**Residential Development,
Aderrig Phase 2, Adamstown,
Co. Dublin**

Stage 1 Road Safety Audit

2.1. Problem: Tactile paving for visually impaired

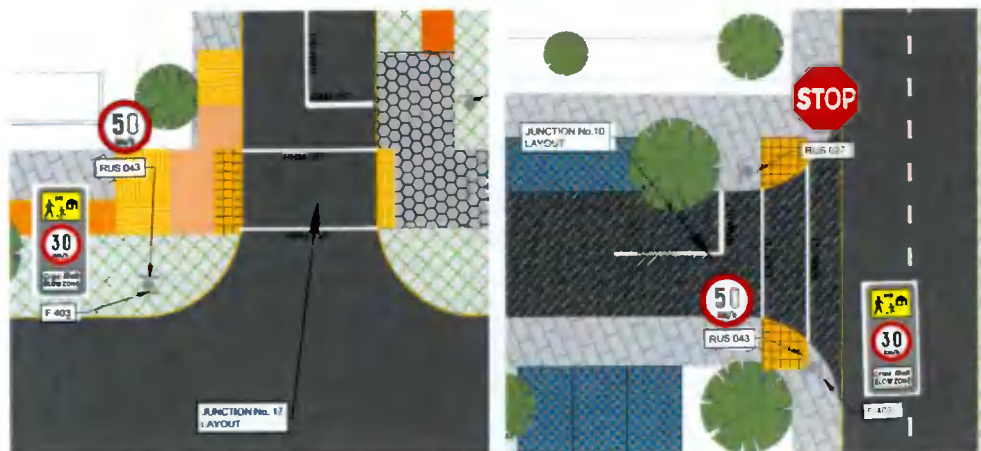
Location: Homezone Streets and Side Streets

The provision of tactile / blister paving at crossing locations is either missing or insufficiently provided across some homezone streets and side streets. Where such surface features are found to be deficient, there is potential for visually impaired pedestrians to inadvertently step out into the adjacent live carriageway resulting in an increased risk of pedestrian-vehicle collisions.

Recommendation

The Design Team should review the design provision / application of tactile paving at all crossing locations across the scheme, taking cognisance of required paving arrangement, colour and extent.

2.1	Y	Y		
2.2	Y	Y		
2.3	Y	Y		
2.4	Y	Y		
2.5	Y	Y	Parking space locations will be adjusted at detailed design stage to ensure appropriate visibility is achieved.

2.3. Problem: Formal Crossing Facilities vs Pedestrian Desire Line

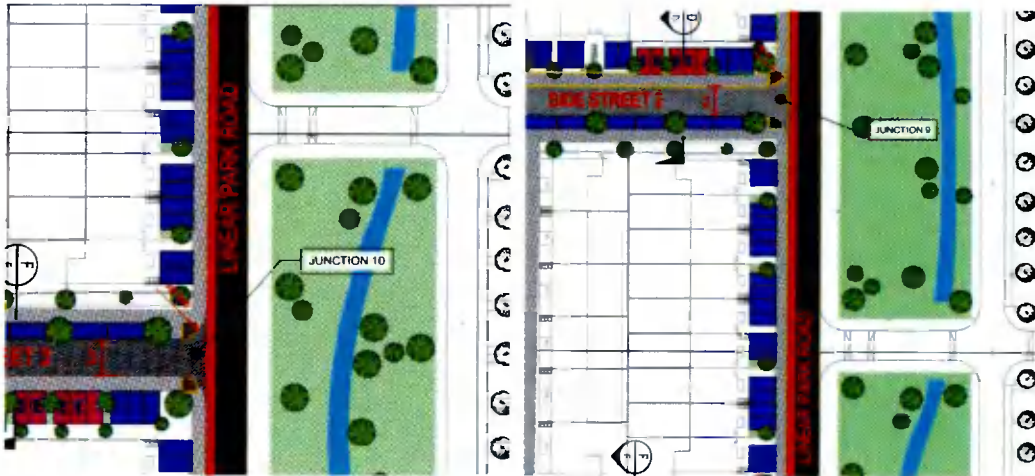
Location: Linear Park Road

Given there is an apparent pedestrian desire line between the proposed development to the west of Linear Park Road and the linear park to the east, the proposed design does not make any provision for formalised crossing facilities to accommodate safe access to the parkland area. Where no formal crossing facilities are provided, pedestrians may attempt to cross the road in an area where it is unsafe to do so leading to an increased risk of pedestrian-vehicle conflicts.

Recommendation

The Design Team should consider provision of formalised crossing points along Linear Park Road. Such provision should be consistent with others provided in the area for similar road type and posted speed limits.

2.4. Problem: Visibility at Junctions

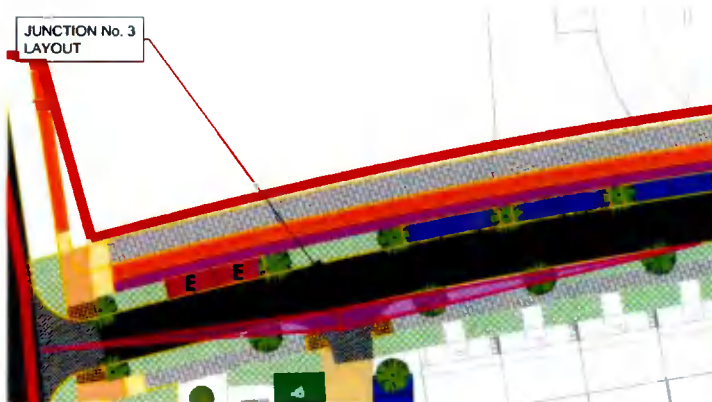
Location: General / All junctions

Where proposed landscaping measures are located in the vicinity of proposed junctions, there is potential for landscape elements (e.g. shrubs, trees, etc) to encroach into visibility envelopes over time. Where visibility at junctions is compromised / reduced, there is increased risk of side swipe type vehicle-vehicle collisions or cycle-vehicle collisions where vehicles emerging from the minor road have inadequate visibility to approaching traffic.

Recommendation

The Design Team should ensure that all landscaping elements are located away from junctions / visibility splays.

2.5. Problem: Visibility at Junction

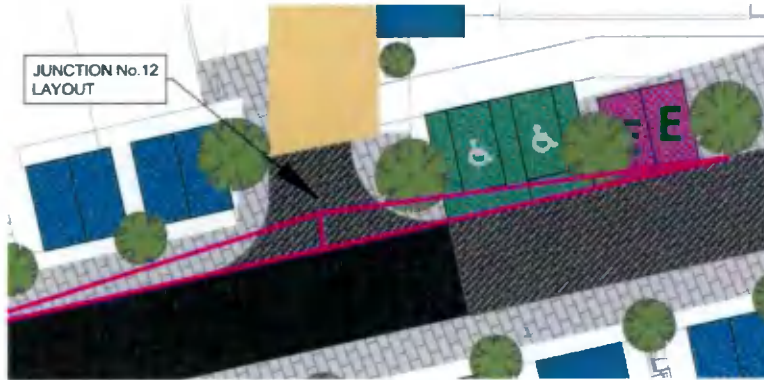
Location: Junction No 12

Where a vehicle occupies the proposed accessible parking area or e-parking spaces immediately east of Junction No 12, there is an apparent encroachment into the visibility splay for the junction. This may be further exasperated by the proposed landscaping proposed in the same area (ref Item 2.4 above). Where visibility at junctions is compromised / reduced, there is increased risk of side swipe type vehicle-vehicle collisions or cycle-vehicle collisions where vehicles emerging from the minor road have inadequate visibility to approaching traffic.

Recommendation

The Design Team should ensure the proposed visibility splays will not be compromised by adjacent parking provision.

2.6. Problem: Inadequate Parking Provision

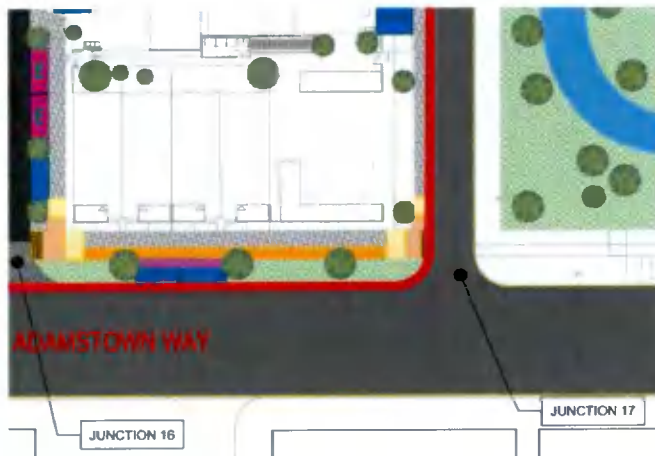
Location: Junction No 16 & Junction No 17

The proposed 4 No residential and 1 No Flexible use units located between Junction No 16 and No 17 appear to have 2 No parking spaces between them. Where an insufficient allocation of parking is provided, residents will park outside their properties thereby adversely affecting the visibility splays at these adjacent junctions. Where visibility at junctions is compromised / reduced, there is increased risk of side swipe type vehicle-vehicle collisions or cycle-vehicle collisions where vehicles emerging from the minor road have inadequate visibility to approaching traffic.

Recommendation

The Design Team should consider provision of additional parking allocations in this area, inclusion of parking control measures to ensure the proposed visibility splays (on major road) and junction approaches (on minor road) will not be compromised by potential on-street parking.

2.6	N	N	A total of 378 No. car parking spaces are provided for the 227 dwellings, a ratio of 1.6 spaces per dwelling. The location of these spaces has been carefully designed to ensure car parking is provided as close as reasonably possible to each dwelling. Additional car parking spaces located within 20metres on Side Street 4. The level of car parking is considered sufficient as shown in BKD drawing 6259-P-006 Parking Strategy. Appropriate Traffic Regulation Orders will be used on Adamstown Way to remove risk of inappropriate on-street car parking	Y

2.7. Problem: Access for Larger Vehicles

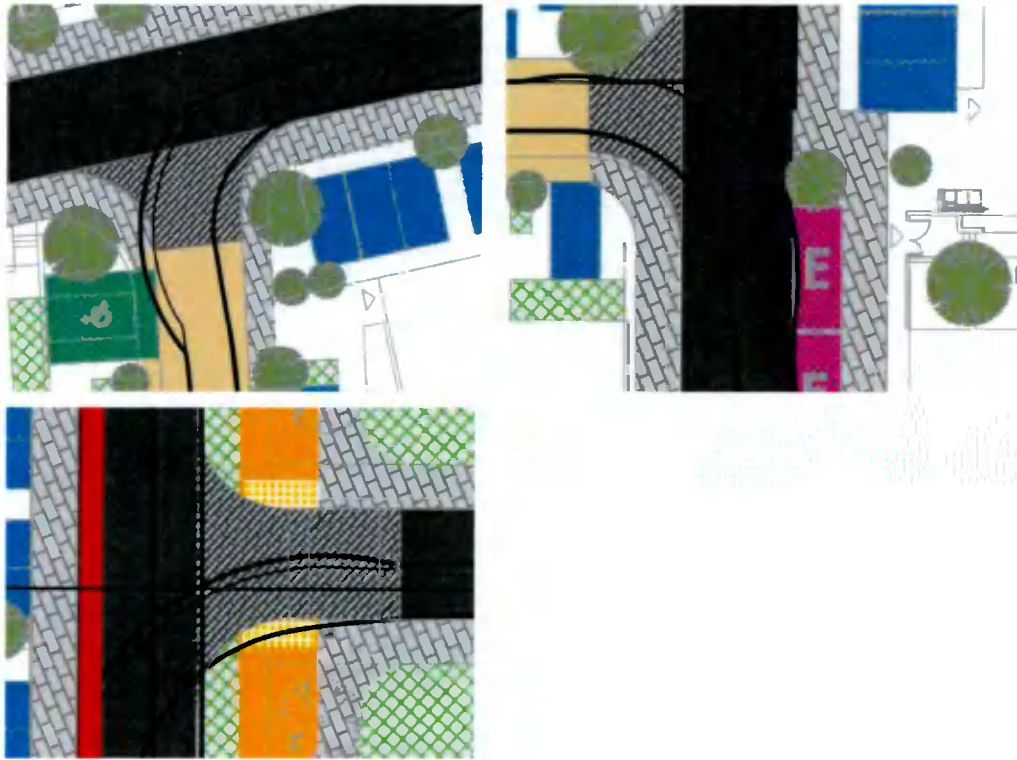
Location: Homezone Streets and Side Streets

Where access is required by larger vehicles (e.g. service vehicles [refuse truck] or emergency vehicles) the swept path analyses provided indicate that some turning movements would require the vehicle to mount footpaths when turning into a given street. This may lead to an increased risk of head-on type vehicle-vehicle collisions or larger vehicles being required to traverse pedestrian areas increasing the risk of vehicle-pedestrian collisions.

Recommendation

The Design Team should consider design measures or other alternative measures as appropriate to ensure such vehicles can safely pass through these junctions.

2.7	Y	Y		
2.8	Y	Y		
2.9	Y	Y

2.8. Problem: Inappropriate road markings

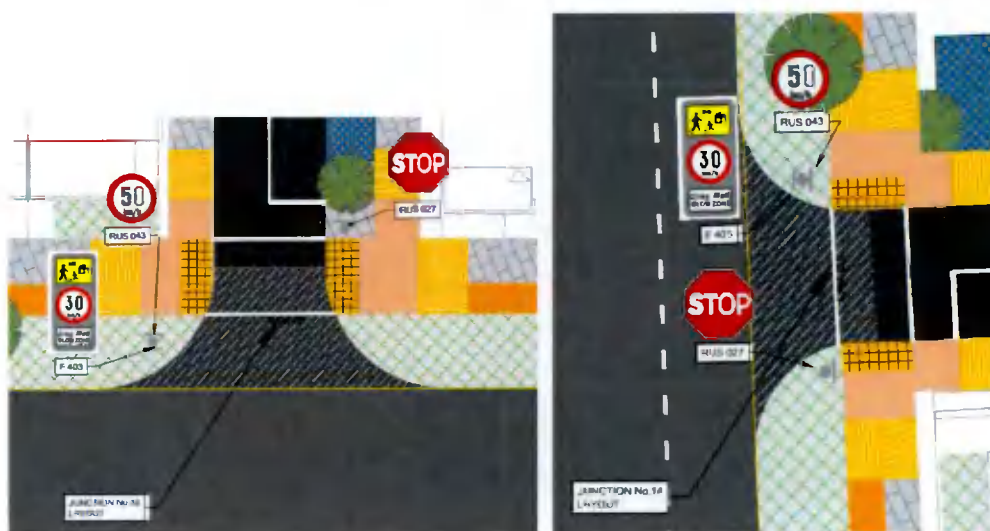
Location: General / All junctions

Pedestrian lines to M 131 of the Traffic Signs Manual are proposed at all uncontrolled pedestrian crossings. Pedestrian lines to M 131 of the TSM are used exclusively at signal controlled junctions. Provision of M 131 pedestrian lines at uncontrolled junctions may lead to pedestrian confusion in relation to crossing priority and cause pedestrians to step onto the carriageway when inappropriate to do so. This may lead to an increased risk of vehicle-pedestrian collisions.

Recommendation

The Design Team should remove the proposed M 131 pedestrian lines at all uncontrolled pedestrian crossings.
